# Access Compliance Report

## Public Rights-of-Way

### (Curb Ramps)

Intersection ID: 14366	Main Street: E_KINGSTON_AV	Cross Street: WINTHROP_AV	Location:	N
ADA ID: B441CEF59EEF	Ramp Type: Directional1	Initial Pass/Fail: Fail	Overall Compliance: No	Severity Score: 22.5

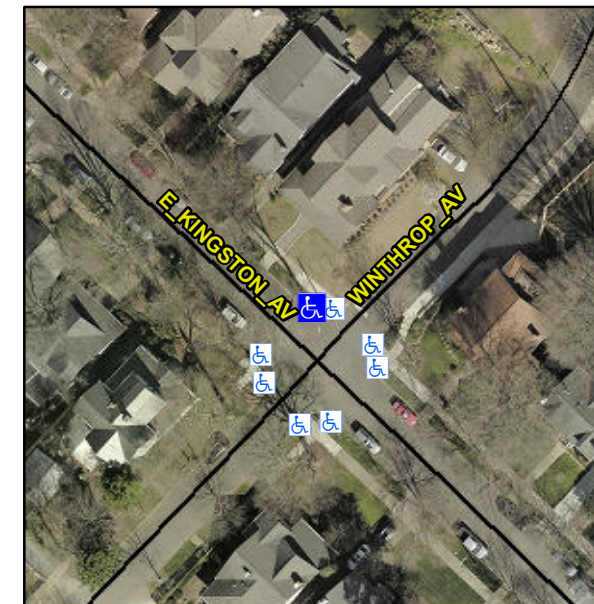
**LNDG GAP 1.0"**

**R304.5.1, R304.2.2, R304.5.3**

**Remove & Replace Entire Ramp.**
